WELL API NO. 30-015-27456
5. Indicate Type of Lease STATE [X] FEE []
6. State Oil & Gas Lease No.
7. Lease Name or Unit Agreement Name INDIAN HILLS STATE COM
8. Well Number #006
9. OGRID Number 306564
10. Pool name or Wildcat [15475] DAGGER DRAW;UP PENN, SOUTH (ASSOC)

SUNDRY NOTICES AND REPORTS ON WELLS
(DO NOT USE THIS FORM FOR PROPOSALS TO DRILL OR TO DEEPEN OR PLUG BACK TO A DIFFERENT RESERVOIR. USE "APPLICATION FOR PERMIT" (FORM C-101) FOR SUCH PROPOSALS.)
1. Type of Well: Oil Well [] Gas Well [X] Other []
2. Name of Operator OXY USA WTP LP
3. Address of Operator PO BOX 4294, HOUSTON, TX 77210
4. Well Location
Unit Letter K : 1980 feet from the SOUTH line and 1980 feet from the WEST line
Section 36 Township 20S Range 24E NMPM County EDDY
11. Elevation (Show whether DR, RKB, RT, GR, etc.)

INDIAN HILLS STATE COM #06

P&A PROCEDURE

Proposed Wellbore

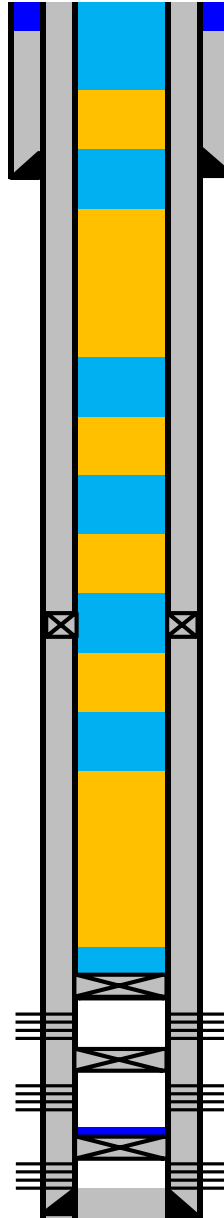
SEE CHANGES TO PROCEDURE

SEE ATTACHED COA'S MUST BE PLUGGED BY 5/1/25

1. Spot 30 sx or Dump Bail 6 sx Cl H cmt on plug at 7700 - WOC & Tag
2. SET CIBP @ 7524'. Test Casing 500psi/30 min. Run CBL to surface Bubble Test - SPOT 30 sx CLASS H CMT or Dump Bail 6 sx ON TOP 7524'-7489'. WOC AND TAG.
3. SPOT 30 SX CLASS C CMT 6150'-6000'. WOC AND TAG. T Wolfcamp
4. SPOT 30 SX CLASS C CMT 5645'-5509'. WOC AND TAG. DV Tool
5. SPOT 30 SX CLASS C CMT 4500'-4350'. WOC AND TAG. TBS
6. SPOT 40 SX CLASS C CMT 2420'-2200'. WOC AND TAG.
7. SPOT 30 SX CLASS C CMT 1257'-1121'. WOC AND TAG.
8. SPOT 125 SX CLASS C CMT 665'-SURF. WOC AND VERIFY CMT AT SURF.
